Customer Service Notice

Units Affected: All AT40M/P units built from serial numbers 0607CZ0000 (June, 2007) through 1009CZ0118 (October, 2009)

Link Replacement

Figure 1 — Link Location

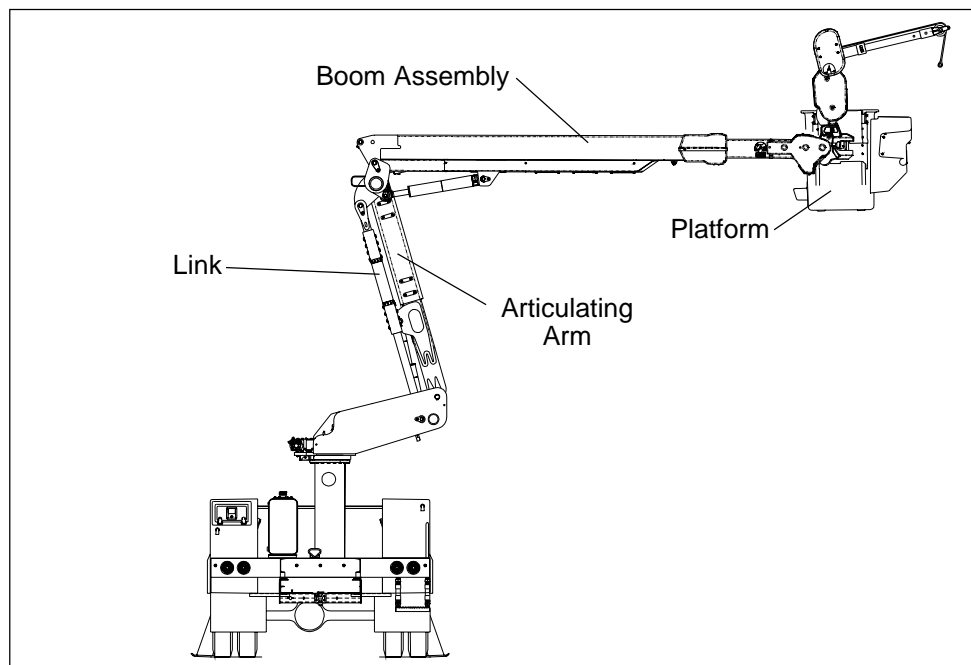
The link on the AT40M/P units is part of the articulating arm assembly (refer to Figure 1). The link is also part of the chassis insulating system on the aerial device. Altec has found rust inside the steel weldment may run over the inner surface of the insulating link and over time compromise the dielectric integrity of the link. The source of the rust within the links was found to be metal particles generated during manufacturing. This condition only effects the quality of the insulating link of the chassis insulating system. The chassis insulating system is not required by industry standards, but was provided by Altec as standard equipment on these units. The insulating properties of the main boom are not effected.

Altec requires that the links on the above listed units be replaced to ensure continued dielectric integrity. The links must be replaced within 60 days of receipt of this CSN. If the chassis insulating system has been dielectrically tested within the last year, the unit may continue to be operated as normal while awaiting link replacement. If the unit has not had the chassis insulating system tested in the last year, such a test should be conducted or crews must treat the link sections as non-insulating. The manufacturing process has been changed and replacement link has been redesigned to address the initial condition.
